MODEL
2017-2018MY
Sportage (QL)

NUMBER
041

TECHNICAL SERVICE BULLETIN

SUBJECT: SERVICE ACTION: EVAPORATOR TEMPERATURE
SENSOR AND/OR ECV REPLACEMENT (SA309)

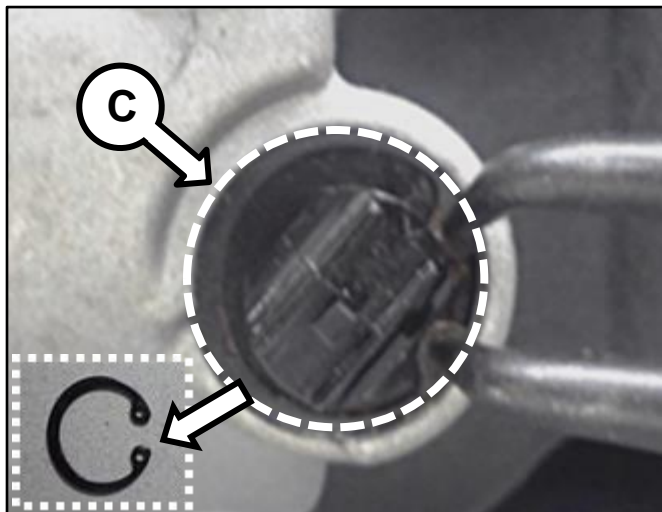
1. Recover the refrigerant by referring to "Heating, Ventilation, Air Conditioning (Air Conditioner) → Air Conditioning System → Repair procedures" chapter in the applicable Workshop Manual found on KGIS.
2. Remove the engine under cover (A).

3. Disconnect the ECV connector (B).

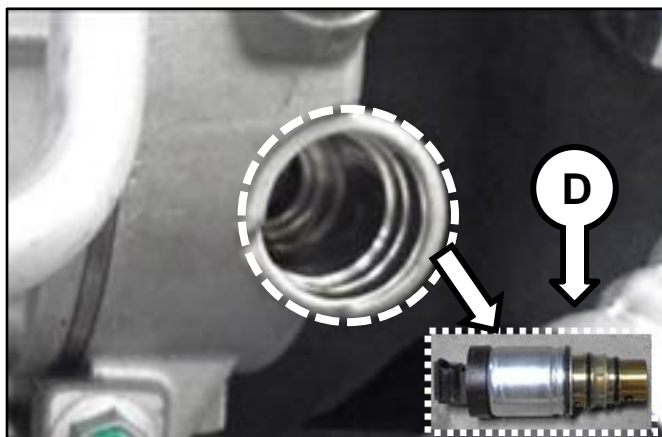
4. Remove the snap ring (C).

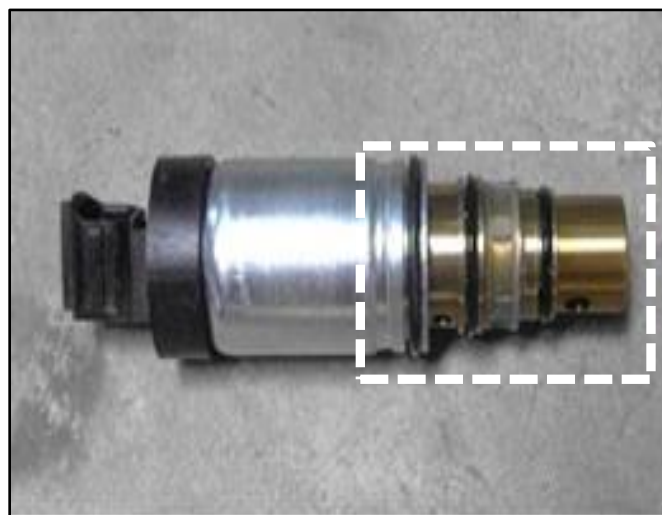
5. Remove and discard the ECV (D).

6. Apply Pag Oil FD46Xg compressor oil onto the O-rings of the new ECV and install it in the reverse order of removal.
7. Replace the Evaporator Temperature Sensor (B) by referring to the "Heating, Ventilation and Air Conditioning → Air conditioning System → Evaporator Temperature Sensor → Repair procedures" chapters in the applicable workshop manual.
